TABLE 3 - COMPARATIVE LIST OF DESIGN CHANGES

R O W	Original Architectural Design	Amended Architectural Design
1	<div>Cover Page</div> <div></div>	<div>Cover page - updated Frenchmans Road streetscape presentation, additional drawings sheets</div> <div></div>
2	<div>DA01 Site Plan</div> <div>Total GFA: 3,785.2m2</div> <div>FSR: 1.397:1</div> <div>Total No. of Beds: 86</div> <div>Total No. of ILUs: 2</div> <div>Total No. of Rooms: 80</div>	<div>DA01 Site Plan Rev B dated 1 June 2021</div> <div>Total GFA: 3,458.4m2 – GFA reduced by 326.8m2</div> <div>FSR: 1.276:1 – FSR reduced by 0.121:1</div> <div>Total No. of Beds: 86</div> <div>Total No. of ILUs: 2</div> <div>Total No. of Rooms: 79 – reduced by 1 room</div>
3	DA02 Site Analysis	DA02 Site Analysis Rev B dated 1 June 2021 – no change
4	DA02a Site Analysis – Location Plan	DA02a Site Analysis Rev B – Location Plan dated 1 June 2021 – no change
5	DA03 Lower Basement Floor Plan	DA03 Lower Basement Floor Plan Rev B dated 1 June 2021 – no change

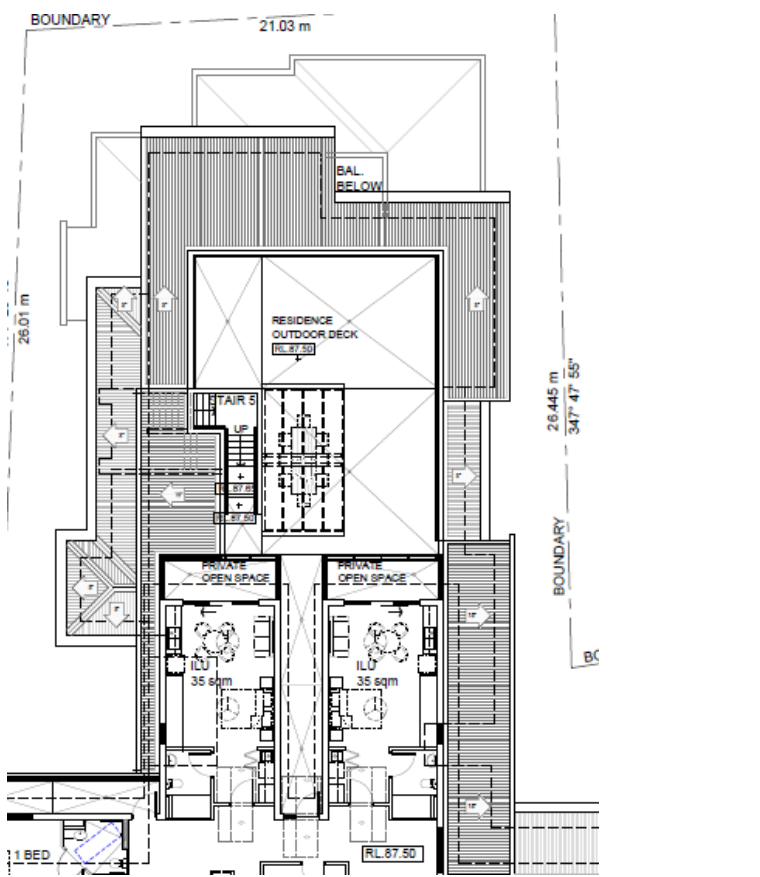
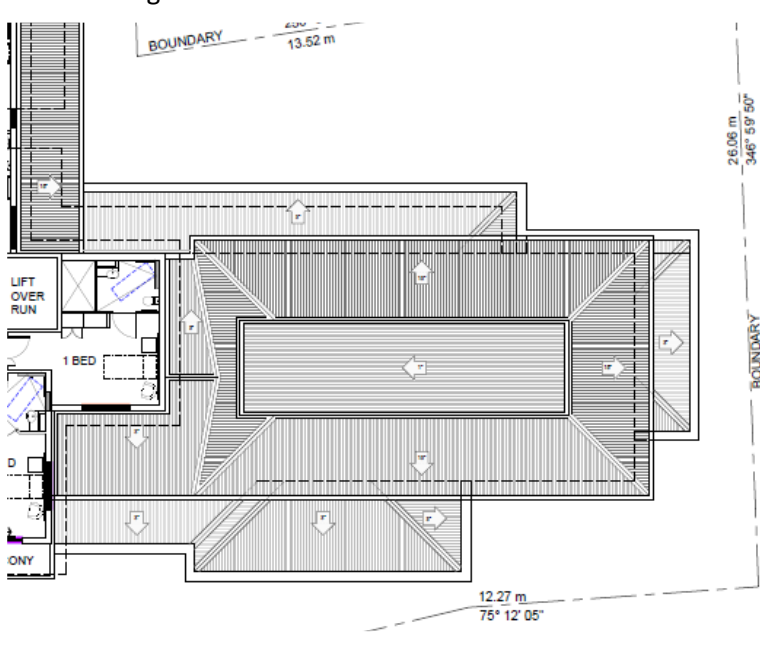
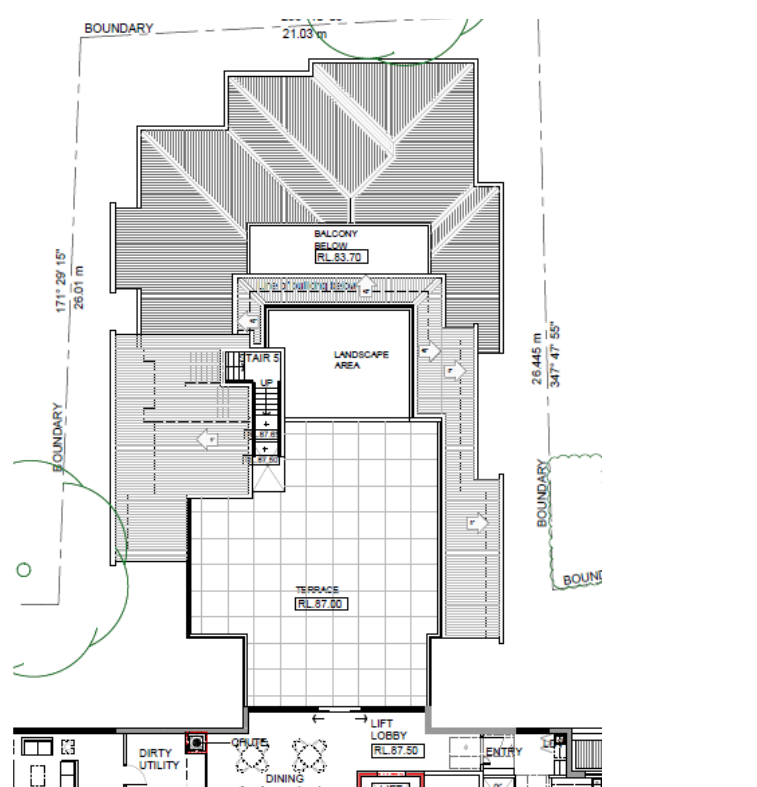
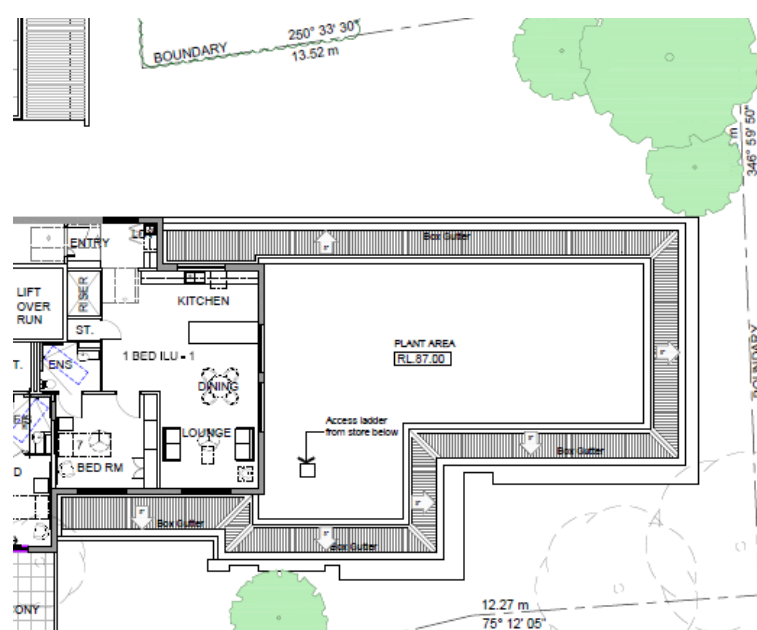
R O W	Original Architectural Design	Amended Architectural Design
1 0	<p>DA08 Third Floor Plan</p> <p>Northern wing</p>  <p>Eastern wing</p> 	<p>DA08 Third Floor Plan Rev B dated 1 June 2021</p> <p>Northern wing – ILUs removed from this section and repositioned to create enlarged roof terrace with landscaped planter bed and amended roof / non-trafficable area surrounds as requested by DEP, increased setbacks from eastern and western boundaries</p>  <p>Eastern wing – inclusion of ILU-1, deleted pitched roofs provision of plant area, provision of parapet surround for acoustic barrier</p>

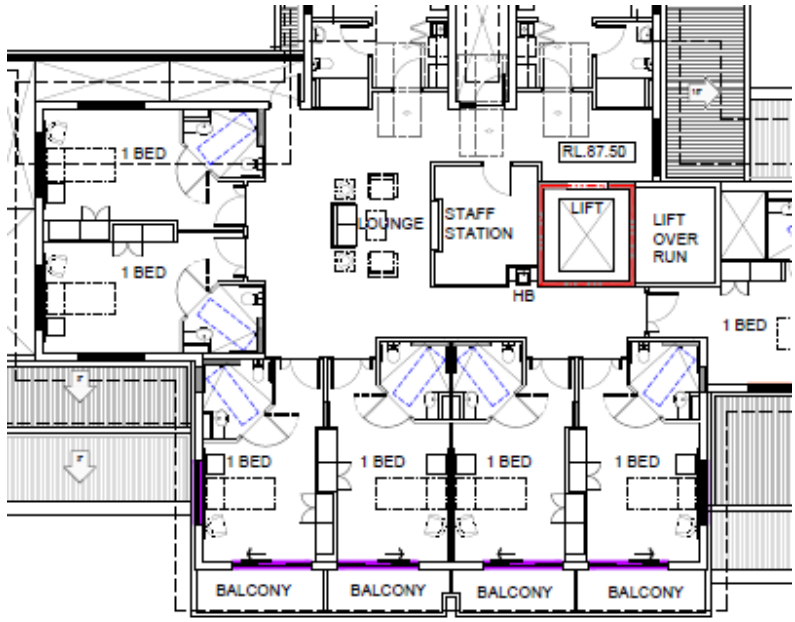
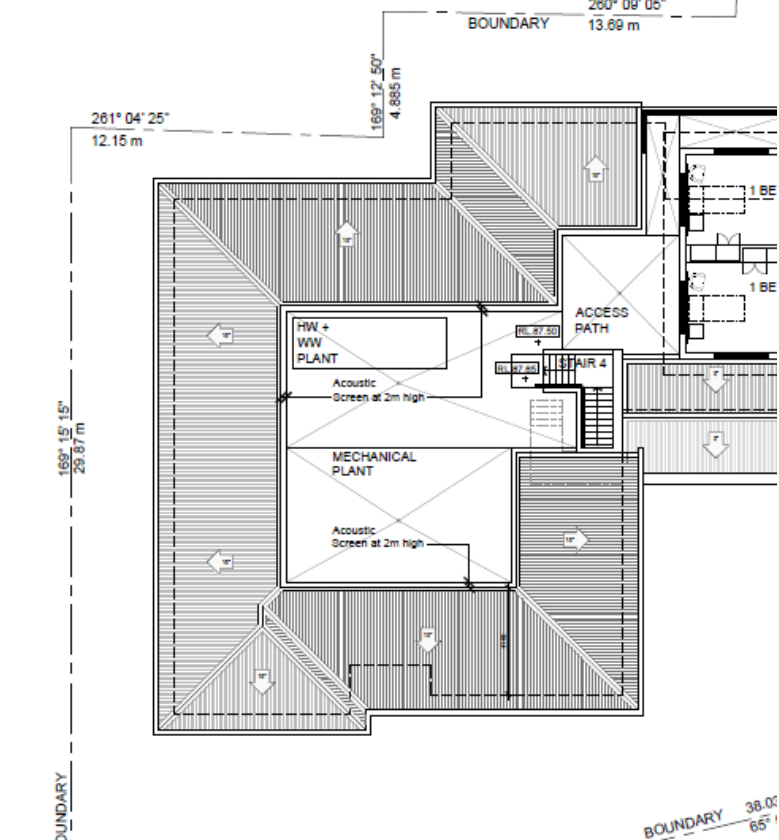
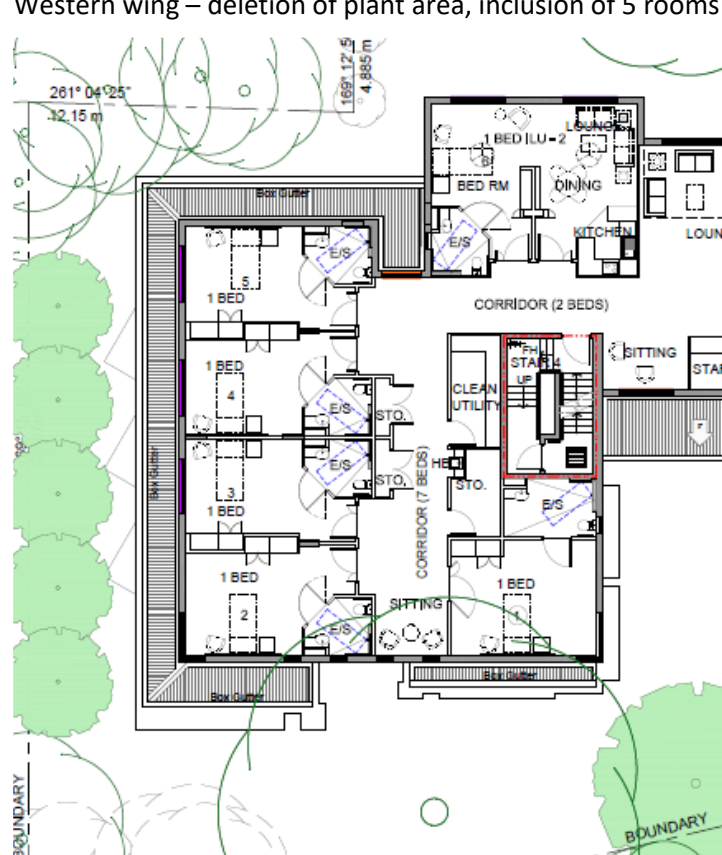
R O W	Original Architectural Design	Amended Architectural Design
	<p>Central core</p> 	<p>Central core – inclusion of balconies to Frenchmans Road elevation</p> 
	<p>Western wing</p> 	<p>Western wing – deletion of plant area, inclusion of 5 rooms which are off-set from the level below by 2m, and ILU-2</p>

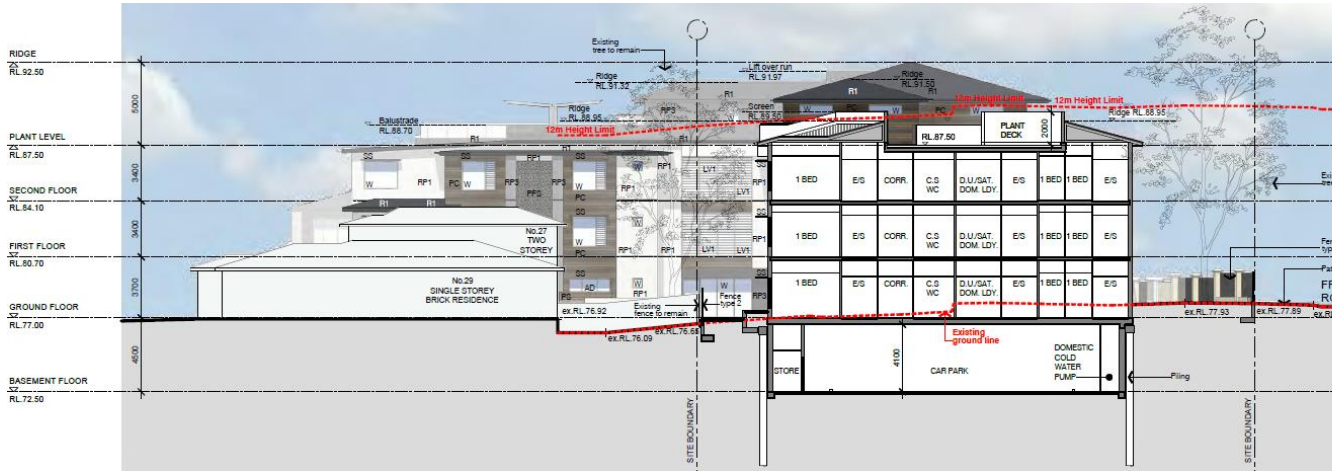
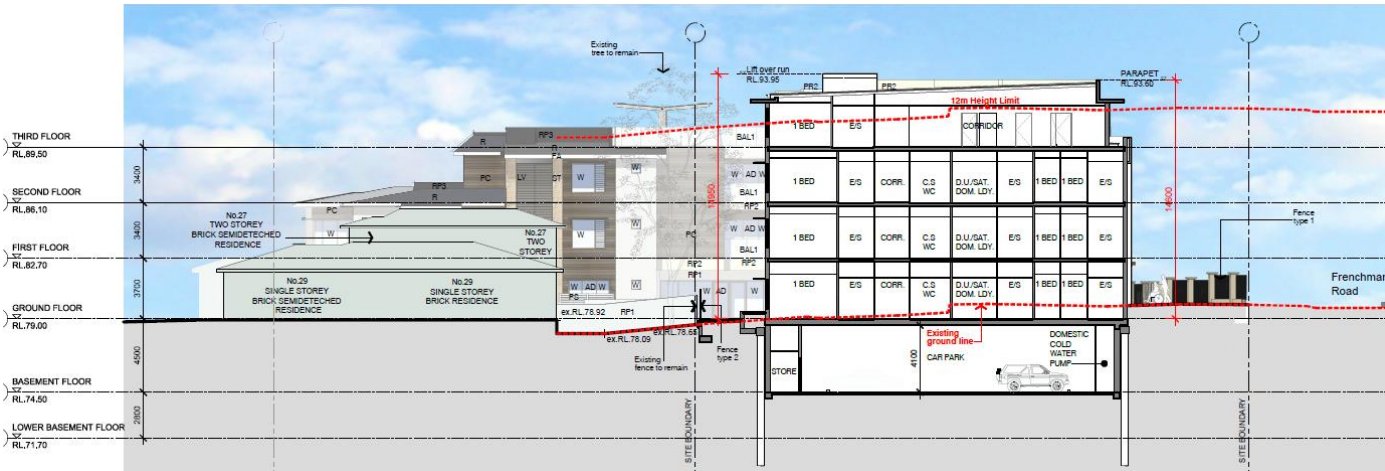
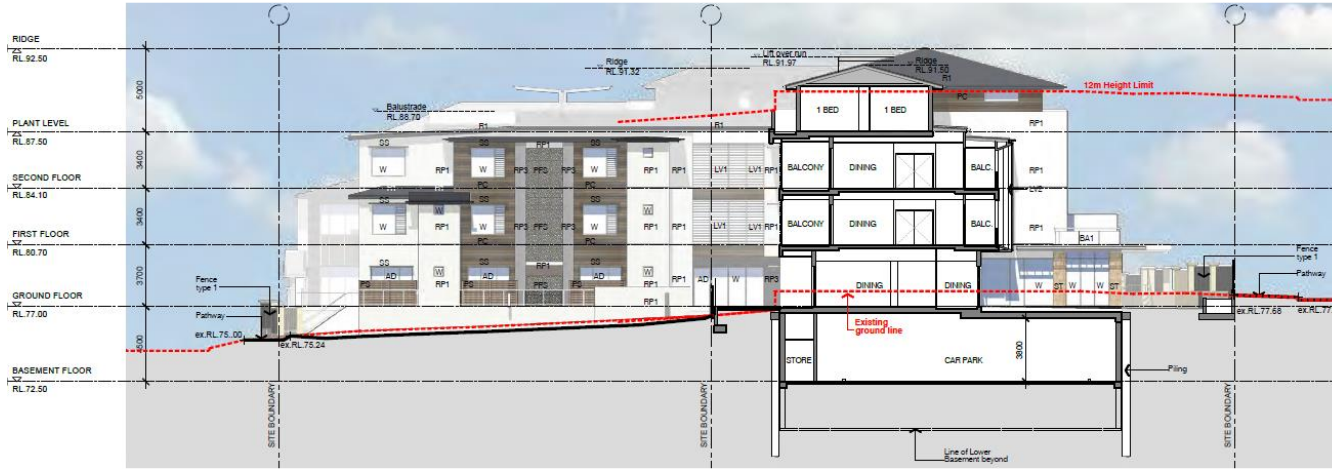
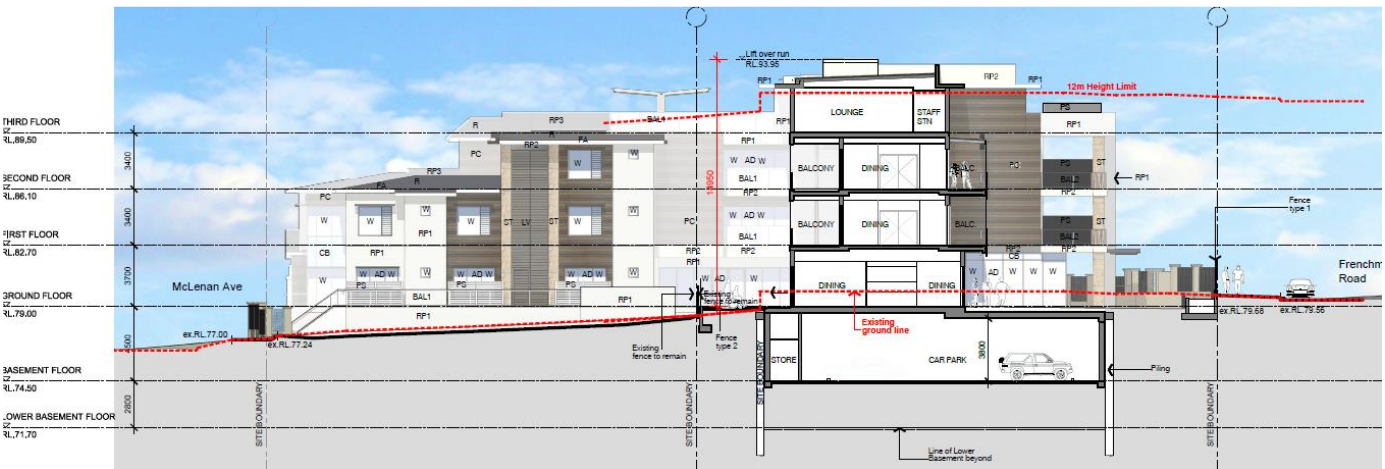
R O W	Original Architectural Design	Amended Architectural Design
	1 1	1 1
1	DA09 Roof Plan	DA09 Rev B Roof Plan dated 1 June 2021 – no longer proposes pitched roof on the upper levels - flat roof
1 2	DA10 Sections (A, B & C) Section A	DA10 Sections (A, B & C) Rev B dated 1 June 2021 Section A – flat roof instead of hipped roof (removed), repositioned plant area

Section B	Section B - flat roof instead of hipped roof (removed), increased setback from Frenchmans Road

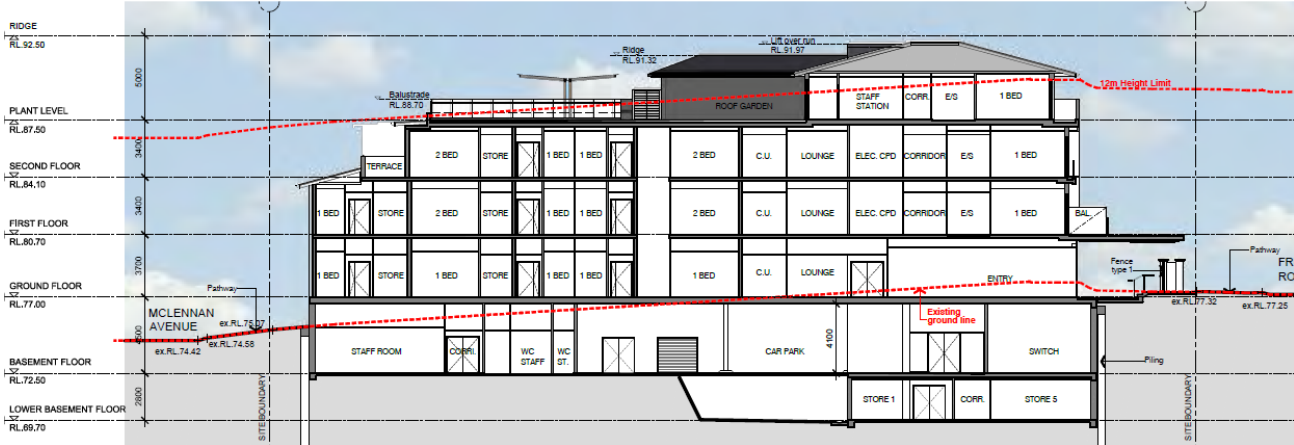
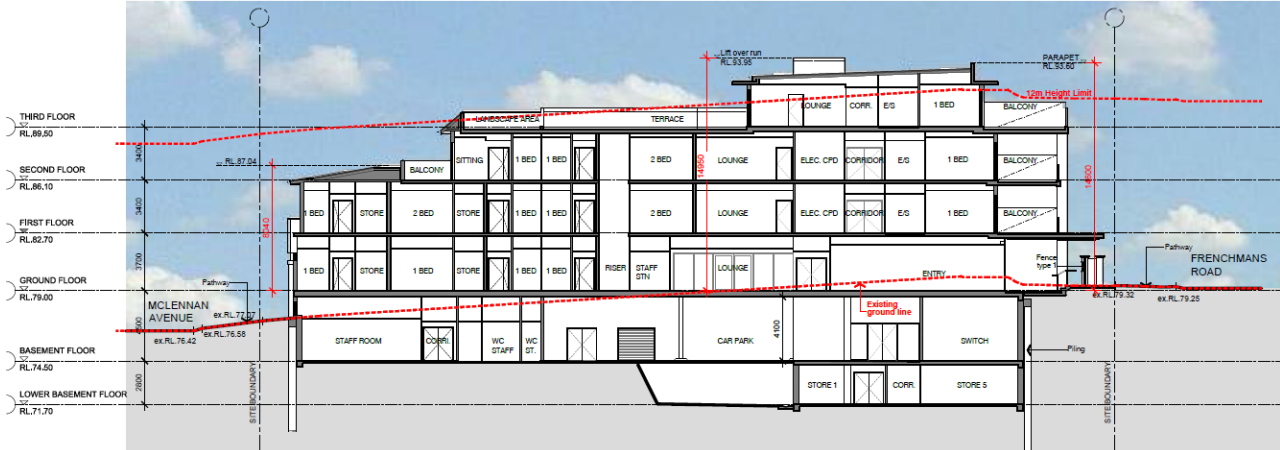
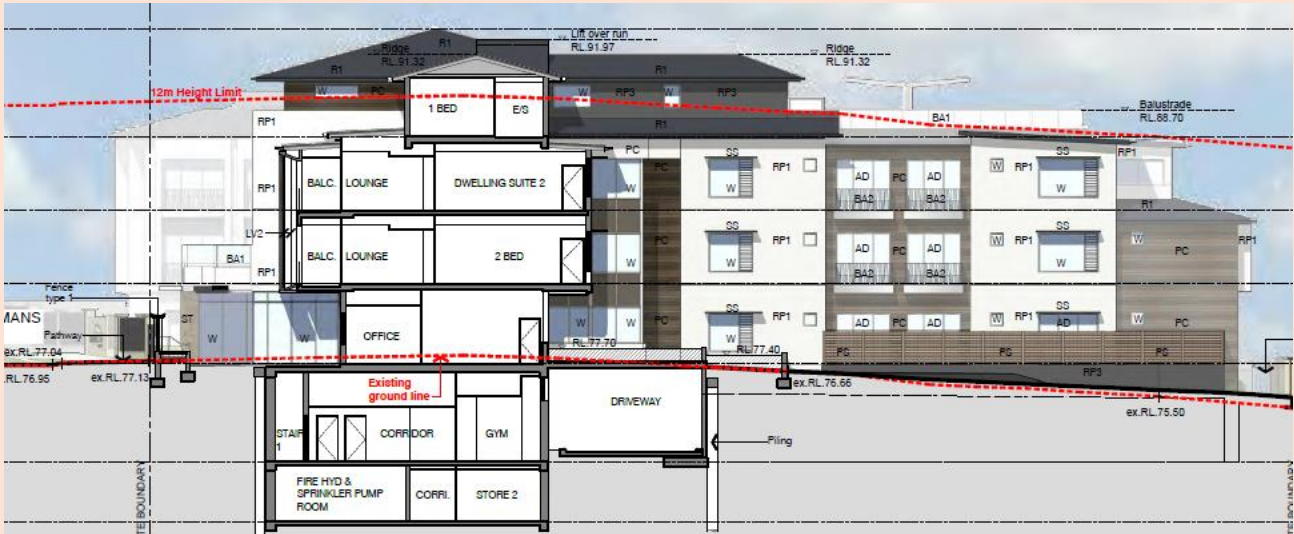
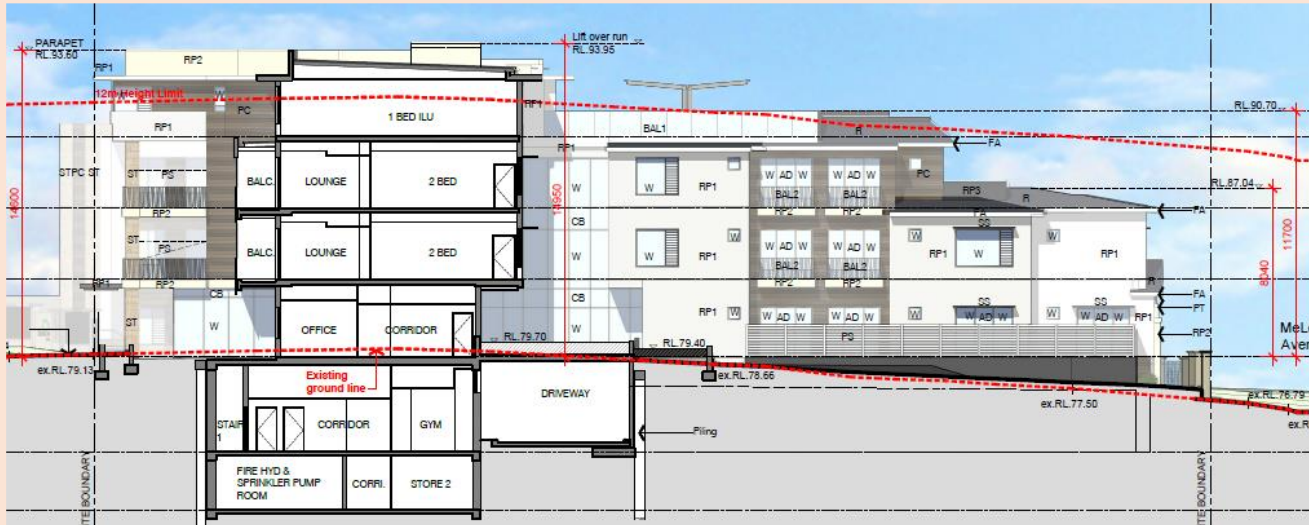
ROW	Original Architectural Design	Amended Architectural Design
	<p>Section C</p> 	<p>Section C – flat roof instead of hipped roof (removed), landscape bed on roof level added, increased setback to upper level 3 from McLennan Avenue</p> 
1	DA11 Sections (D, E, F & G)	DA11 Sections (D, E, & F) Rev B dated 1 June 2021
3	<p>Section D</p> 	<p>Section D</p>
